S21AZ

Subject: S21AZ, Ford 6.8L Air Compressor Belt

Models Affected: Model Year: Certain 2013 through 2022
Model: Vision School Bus and Non-School Bus

S21AZ Ford 6.8L Air Compressor Belt

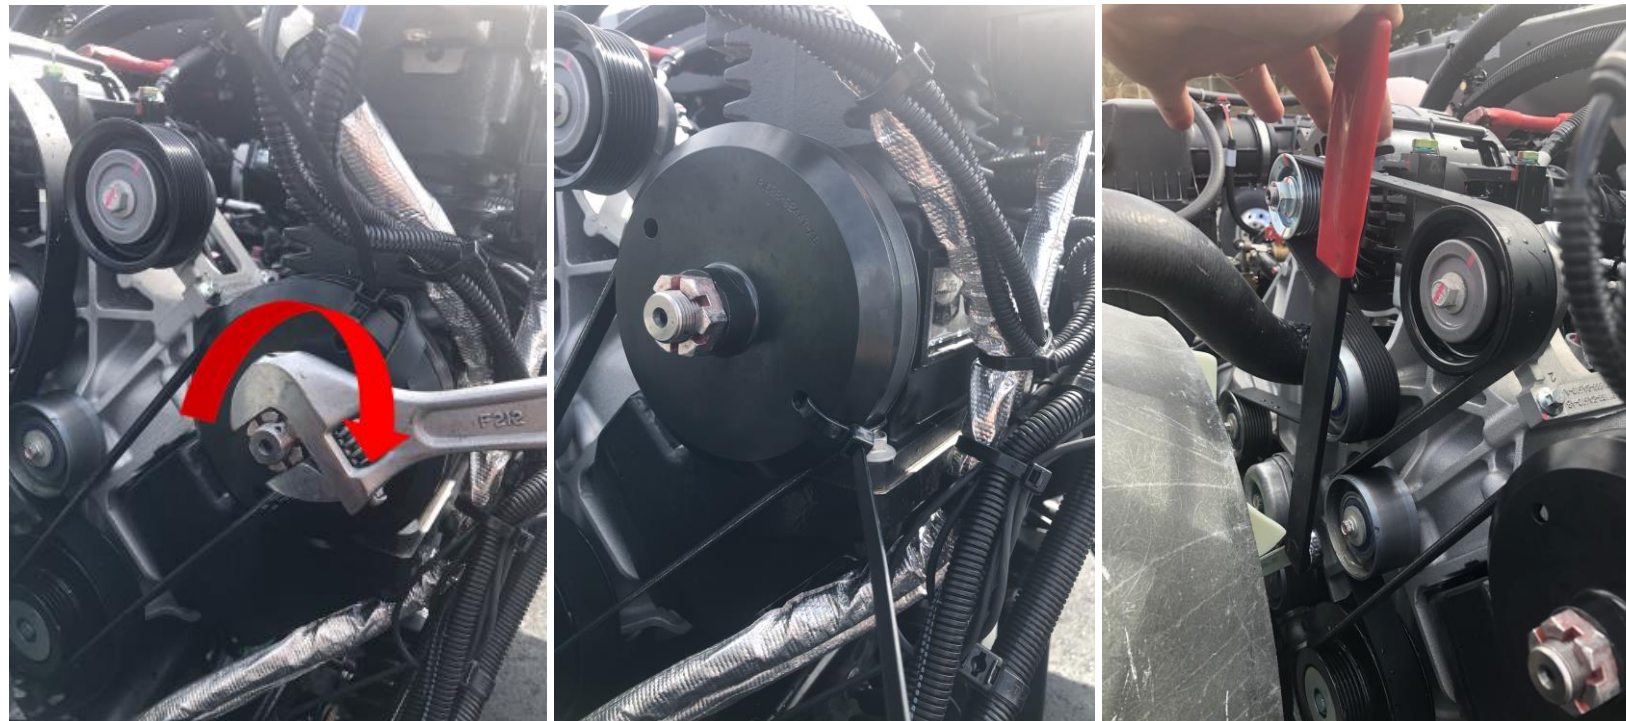
Issue: Certain Units Have Experienced Premature Life of the 3rd Sheave Air Compressor Belt

Corrective Action: Replace Belt with Improved Design

NOTE: Photo below is Gen 4, which is identified by the solid compressor pulley. Gen 3 will have a spoked pulley. Failure to install the correct belt will result in pre-mature failure.

1. Relieve 2nd sheave belt tension by rotating tensioner clockwise by engaging a ribbed belt tool with a 3/8” square drive adapter, then remove 3rd sheave belt.

2. Rotate the compressor pulley to where one of the two holes arrives at the 11:00 position. Loop compressor belt over the 2nd to 3rd sheave adapter and place compressor belt over the top of the air compressor pulley.
3. Ty-wrap into place.

4. Rotate compressor pulley clockwise to seat belt and cut and remove ty-wrap.
5. Re-install 2nd sheave belt.
6. Start engine and verify proper operation.
